Rev.	Revision Description	Drawn by	Checked by	Approved by Designer	Approved by Contractor	Date
02	After FAT, for installation	Tamara Trogrlić	Antonio Aleksić	Grga Kolić		27.7.2026.
01	For manufacturing	Tamara Trogrlić	Antonio Aleksić	Grga Kolić		7.5.2026.
00	First issue	Tamara Trogrlić	Antonio Aleksić	Grga Kolić		27.2.2026.

Project: Reconstruction and Modernisation of HPP Perucica - Phase II

Title: Unit KA2 control cubicle circuit diagrams

Unit KA2 control cubicle circuit diagrams	DRAWING No.: PERU-01-19-170-31-002	REV No.: 02	= UBCJA10GH100
TITLE PAGE	Designer No.:	SALES No.:	PAGE
			PAGE
			1 / 158

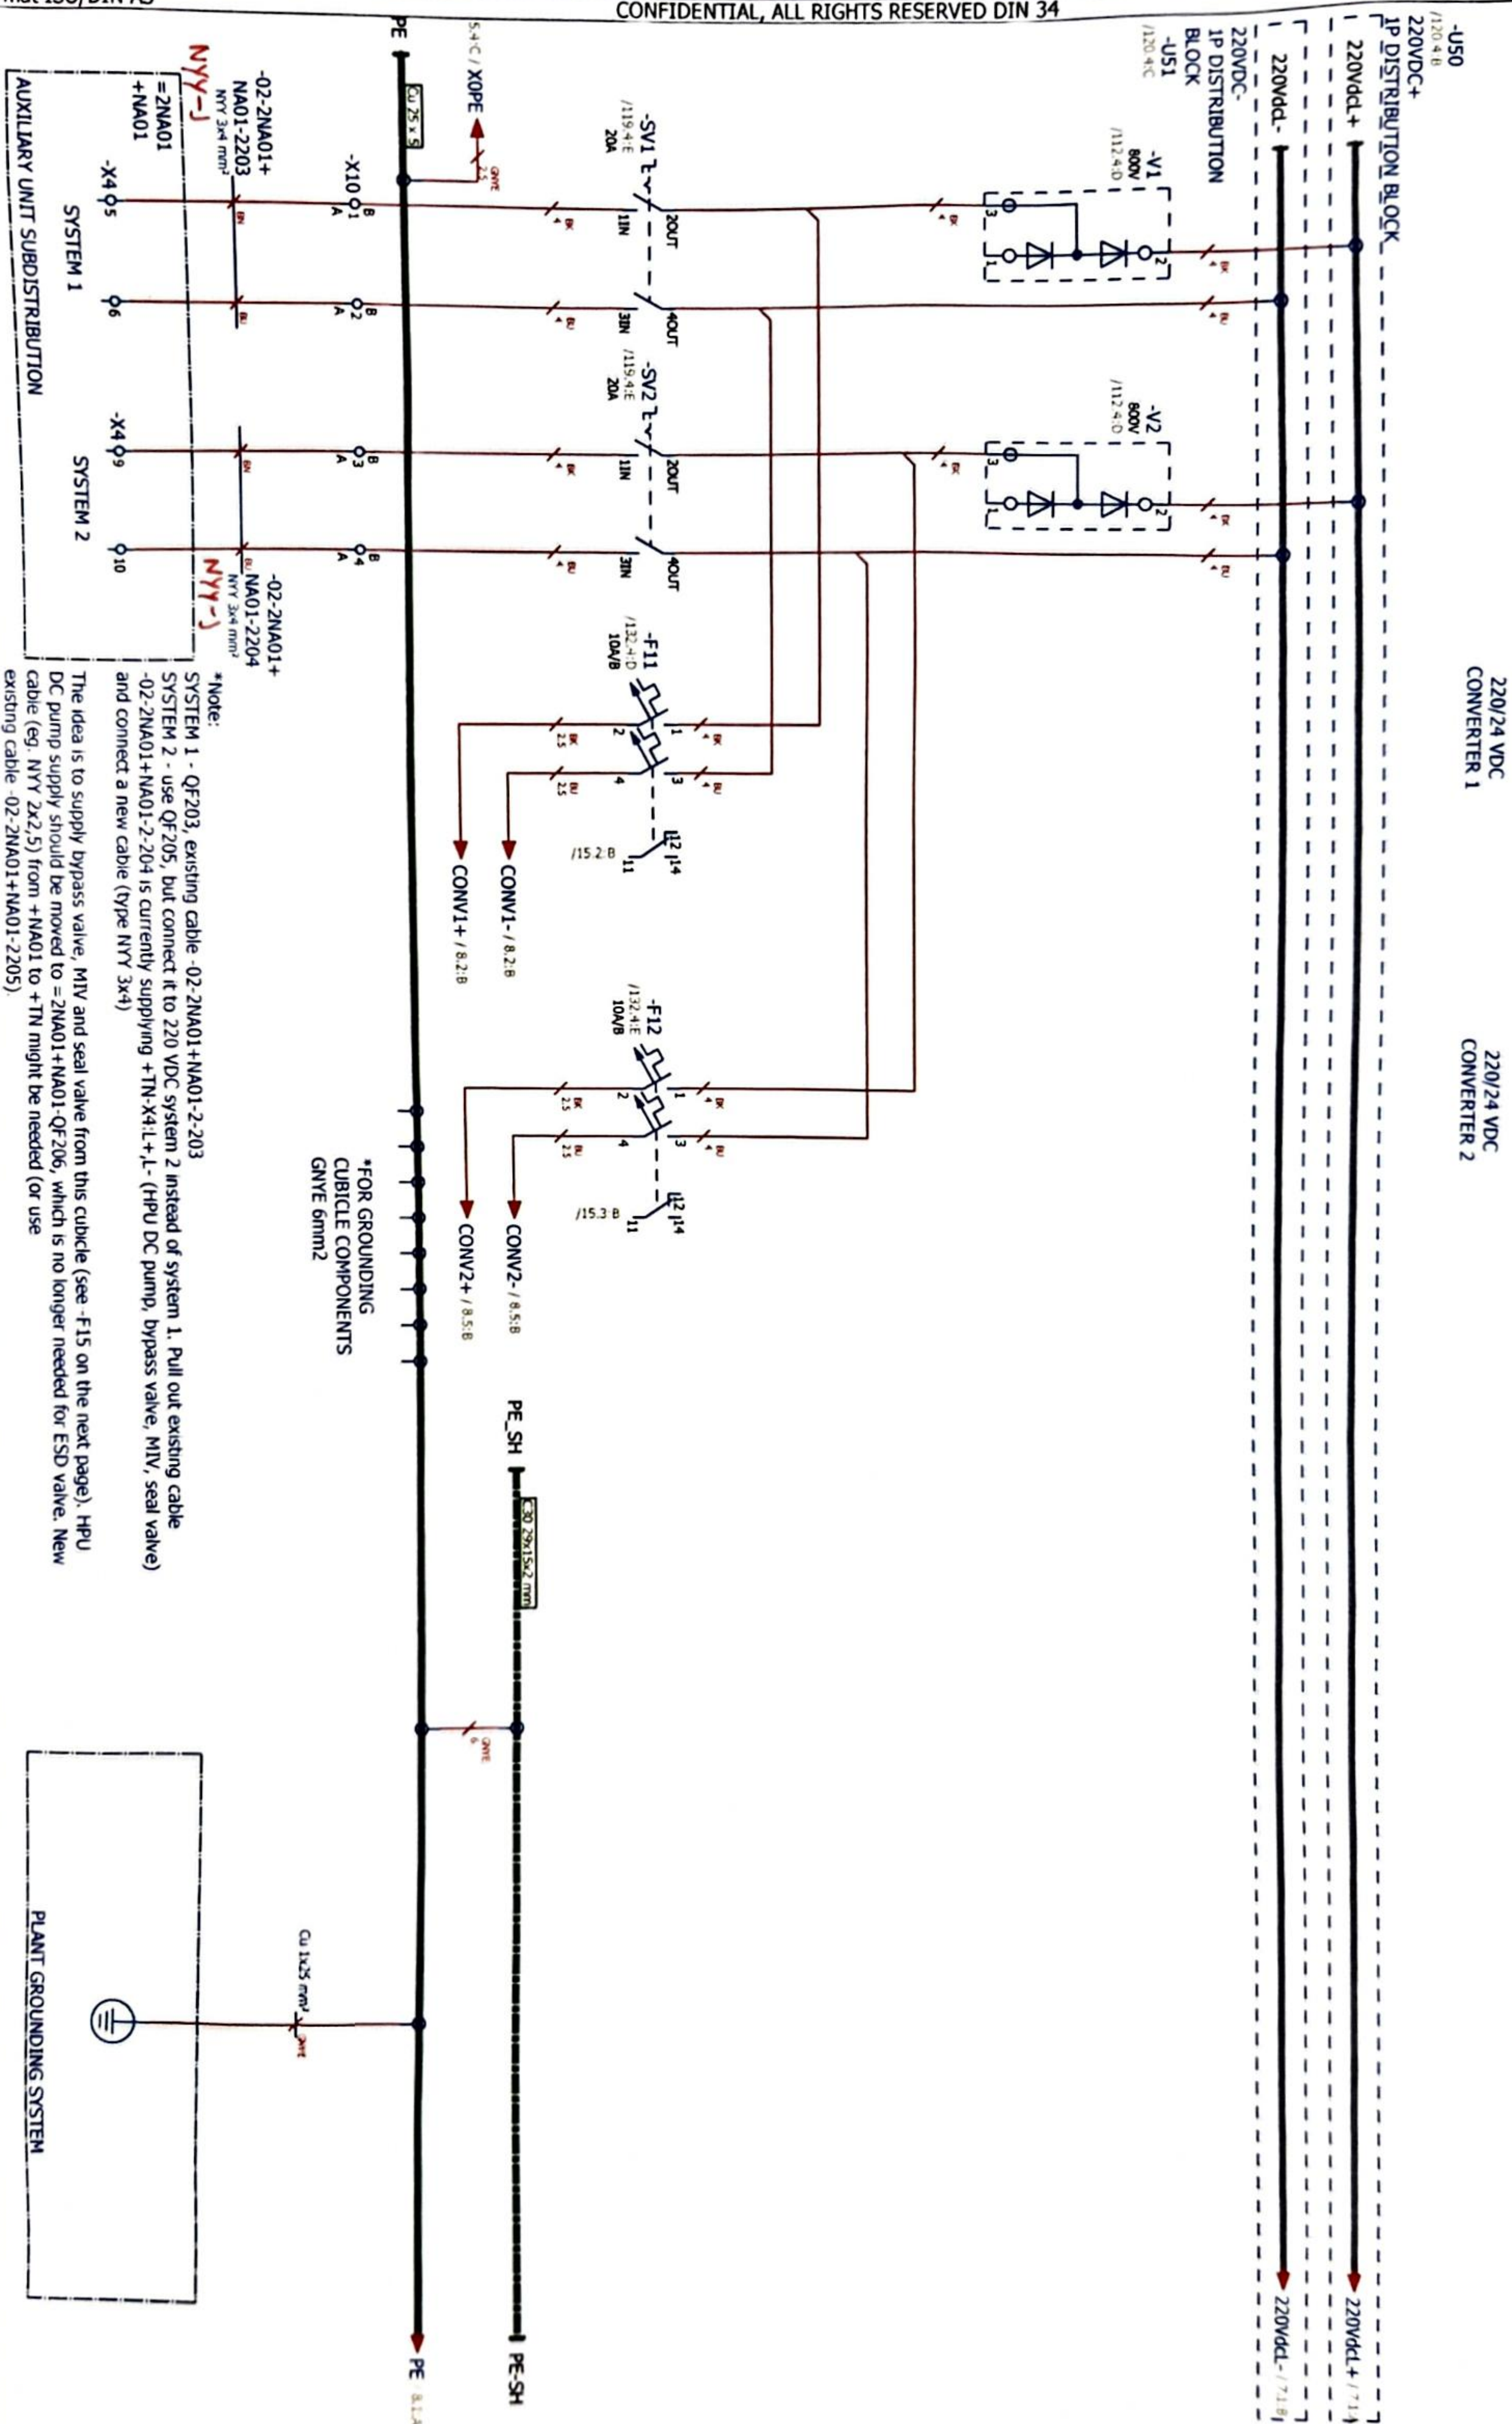
*Note:
Use = 2NA01+NA01-QM4 for KA1 control cubicle service power supply. IMPORTANT: Existing
-02-2NA01+NA01-1-204 cable connections need to be modified as follows:
No changes: BN - 2NA01+NA01-X10:16, GNYE - 2NA01+NA01-X10:19/PE
Change: disconnect BK from X10:17 and GY from X10:18, connect GY to N busbar

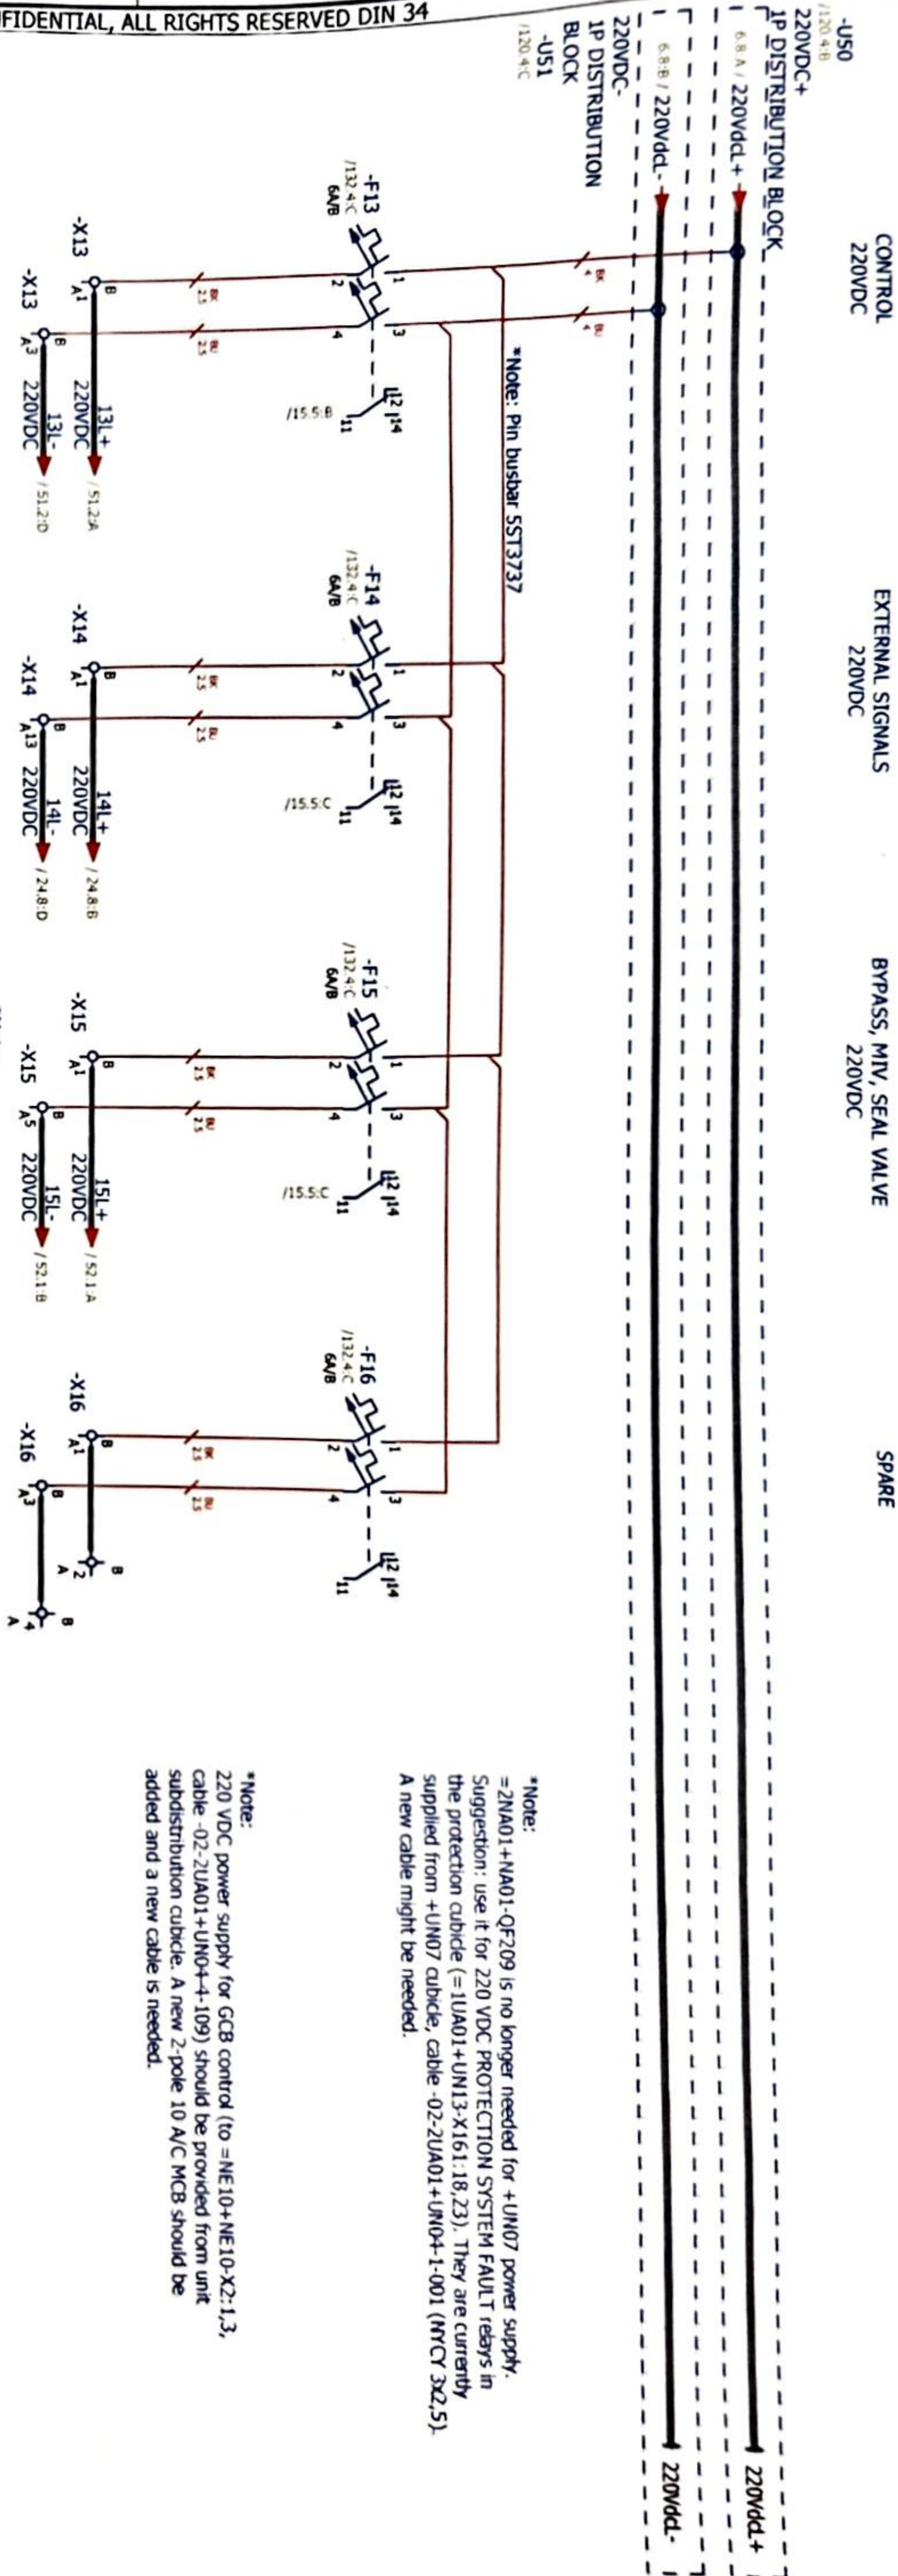
*Note:
=2UA01+NA01-QFZ09 is no longer needed for +UM07 power supply.
Suggestion: use it for 220 VDC PROTECTION SYSTEM FAULT relays in the protection cubicle (=1UA01+UM13-X161;18,23). They are currently supplied from +UM07 cubicle, cable -02-2UA01+UM04-1-001 (HYCY 3x2,5). A new cable might be needed.

*Note: 220 VDC power supply for GCB control (to =NE10+NE10-XZ:1,3 cable -02-2U/A01+UN04+109) should be provided from unit subdistribution cubicle. A new 2-pole 10 A/C MCB should be added and a new cable is needed.

*Note:
This is currently supplied from +TN via +UN07. Since we are planning to supply it from here, -2WK1006 cable cores 1 and 2 are no longer used and also need to be disconnected in the +TN cubicle.

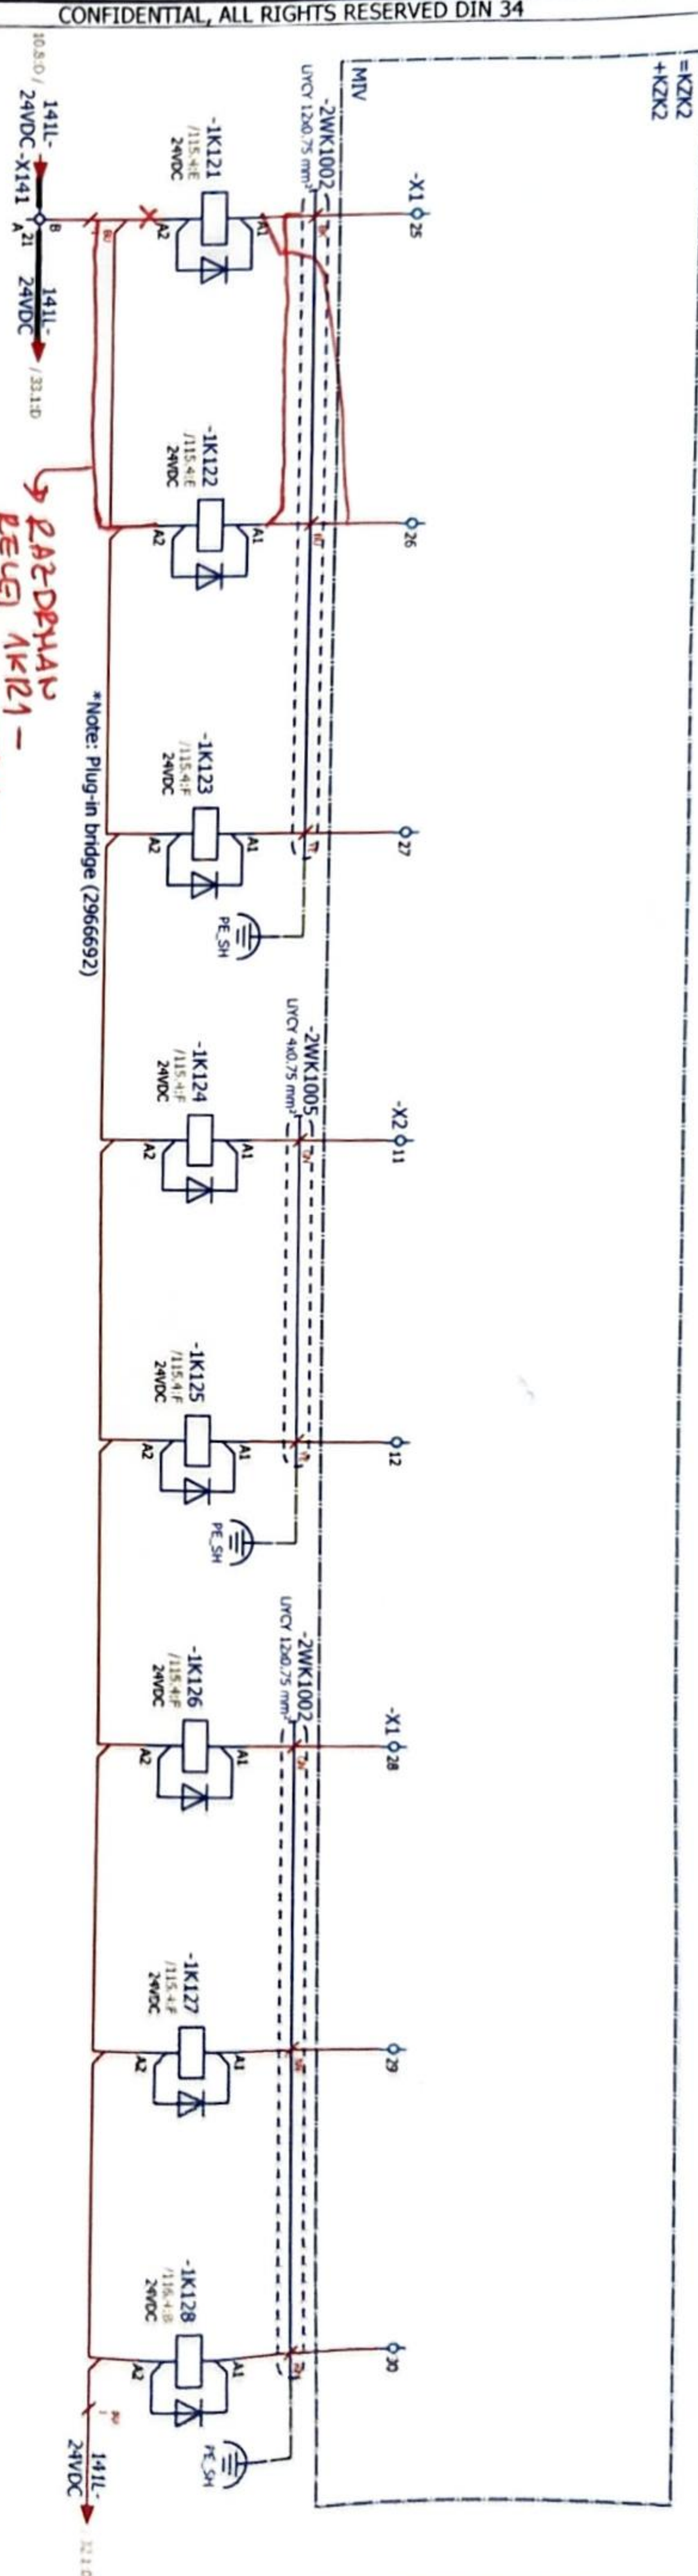
~~MIN CLOSED~~
SPARE

~~SPARE~~
MIN CLOSED
